# Modulators and Isolators for Advanced LIGO

UF LIGO group

28 April 2006

- EOMs
  - » RTP as EO material
  - » RTP has significantly lower absorption and therefore thermal lensing.
  - » Use "industry standard" housing, so can be replaced in existing hardware.
- FI
  - » Uses two TGG crystals/ quartz rotator to cancel thermally induced birefringence
  - » Uses DKDP, a  $-dn/dT$  material, to compensate thermal lensing.
- Performance data and implementation issues presented in “Upgrading the Input Optics for High Power Operation”
- This review tries to answer questions posed by the review panel

# Views to the FI: HAM1

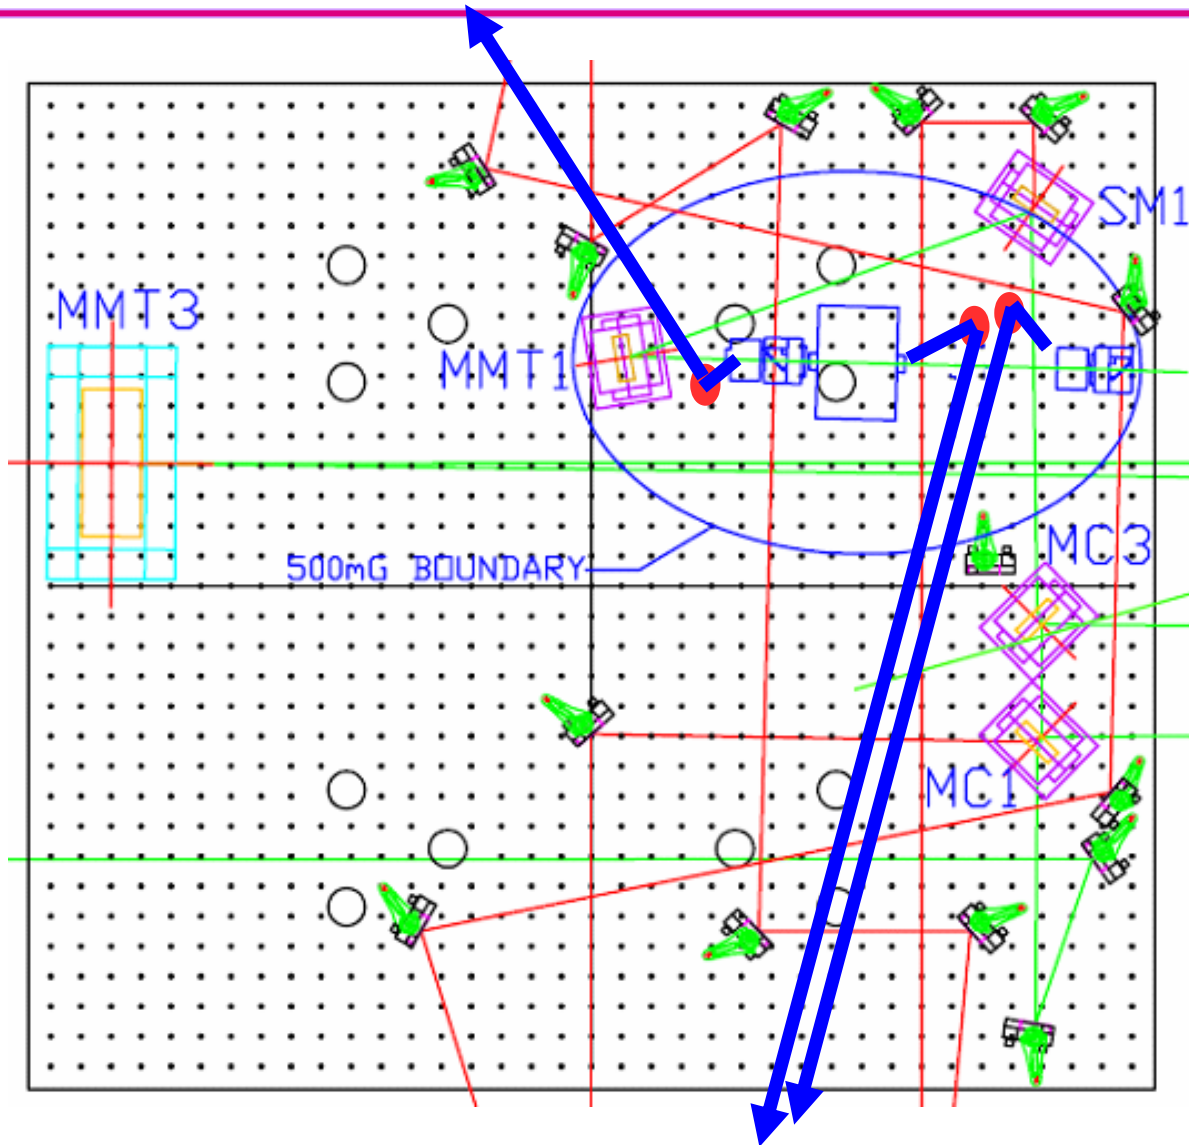
- “Need to think about being able to view important points of the assembly from outside the vacuum system; mirrors may need to be included to provide views.”
- For iLIGO upgrade, it will be possible to place mirrors on the HAM that will provide views from cameras mounted in the upper HAM door viewports
  - » Access to the entrance aperture of the FR on HAM1 may be difficult, because component positions are constrained by beams
    - Should be able to get a look at the polarizer
- For AdvLIGO, layout is still sufficiently preliminary
  - » HAM 1 is relatively clear where FI is located, so FI components can be separated
